RN SERIES TECHNICAL BULLETIN

ISSUE NO. : RNT-010

SUBJECT: 021-12102-305 Arm; Separator
021-12112-009 Lever; Separator
021-12113-005 Adj. Plate; Separator

Newly-registered Part
021-12102-305 Arm; Separator
021-12112-009 Lever; Separator
021-12113-005 Adj. Plate; Separator

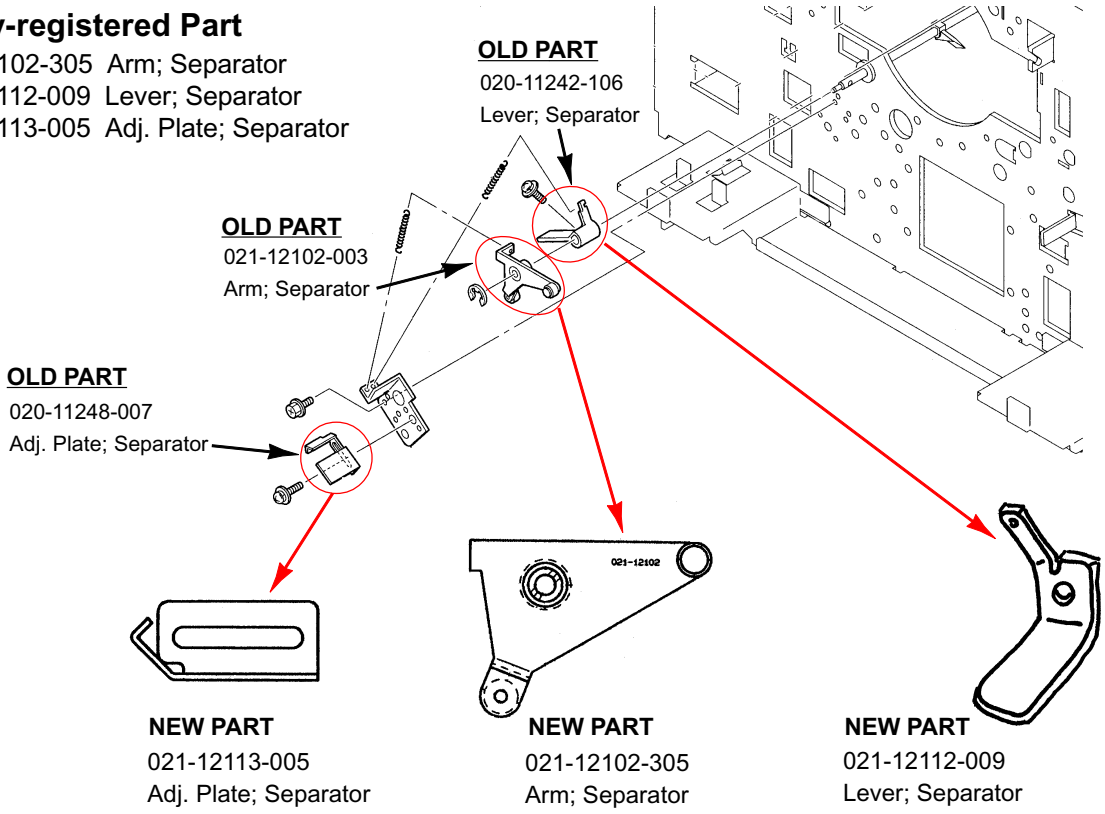
Brief:
The "Lever; Separator" was changed from plastic material to metal.
At the same time, "Arm; Separator" and "Adj. Plate; Separator" is modified to be stronger.

Reason:
The plastic "Lever; Separator" had tendency to deform in time, due to its material. The deformation may cause the position of the Separator to change, and make the tip of the Separator to touch the Drum.
